**BRIEFING ON ACCESSIBILITY-RELATED REQUIREMENTS FOR LIFT CARS (HELD ON 5 APR 2024 & 3 MAY 2024)
FOR LIFT SUPPLIERS/CONTRACTORS**

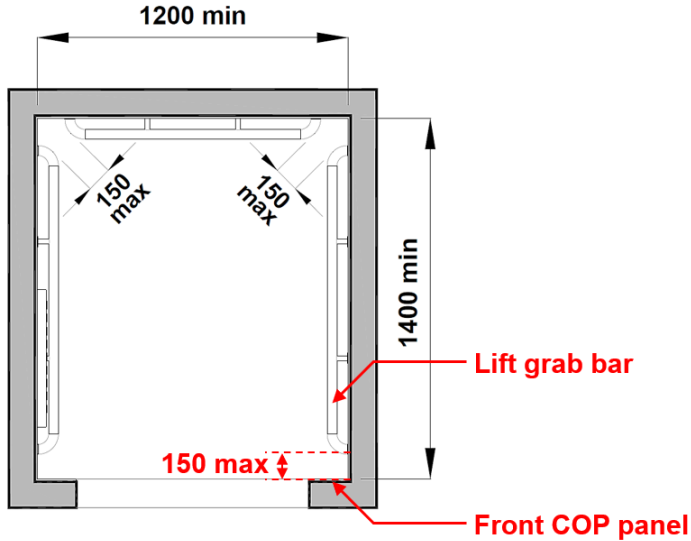
Q&A		
LIFT CAR CONTROL SIDE PANEL		
S/N	Participant's Feedback / Enquiry	BCA's Response
1	Is it mandatory to have an accessible lift car control side panel if the buttons on the front lift car control panels already complied with the height requirements stated in the Code on Accessibility in the Built Environment 2019 ("Code")?	For accessible lifts with more than one control panels, at least one lift car control panel must be placed at the side wall of the lift car. This is because wheelchair users had given feedback on the challenges faced in turning their wheelchairs around to reach the lift control buttons if these were placed at the front. This is more so when the lift is crowded. The buttons on the lift car control side panel must comply with the height requirements stated in the Code.
2	Should the lift car control side panel be located on the left or right side of the lift car upon entering the lift?	It is recommended to place the side panel to the right side of the lift car wall upon entering the lift.

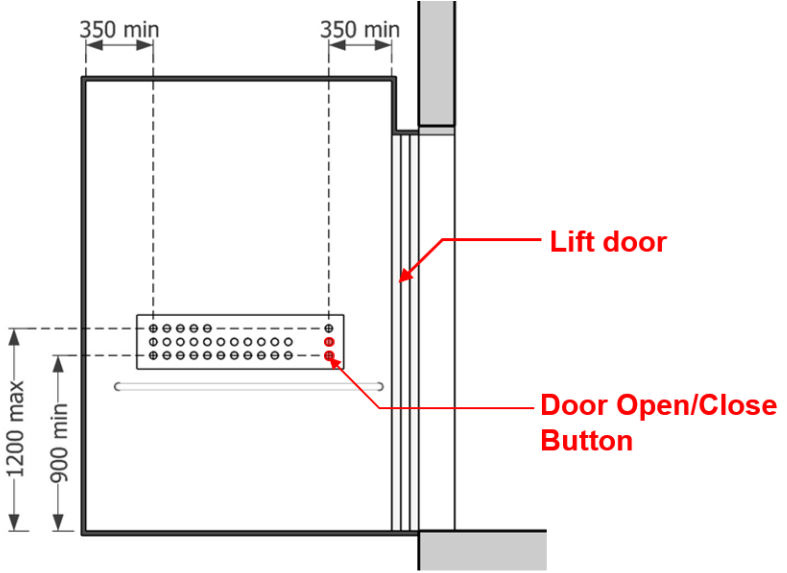
7	For scenic glass lifts ("bubble lifts"), where should the mirror be mounted?	Designers should understand the rationale of having the mirror within the lift car and consider mitigation measures that might allow wheelchair users to safely turn around without the help of the mirror. If your project requires further advice on this, you may consult BCA with the drawings of your proposal and we will advise accordingly.
8	Where should the mirror be placed if there are lift doors on more than one side of the lift car?	Depending on position of the lift doors, whether opposite or adjacent, the mirror should be placed in a way that provides the correct visual feedback required for the wheelchair user to exit the lift car safely. Usually in such cases, mirror-like finishes will be provided either on the lift doors or on more than one side of the lift car walls. If your project is facing difficulties complying with the requirement, you may consult BCA with the drawings of your proposal and we will advise accordingly.
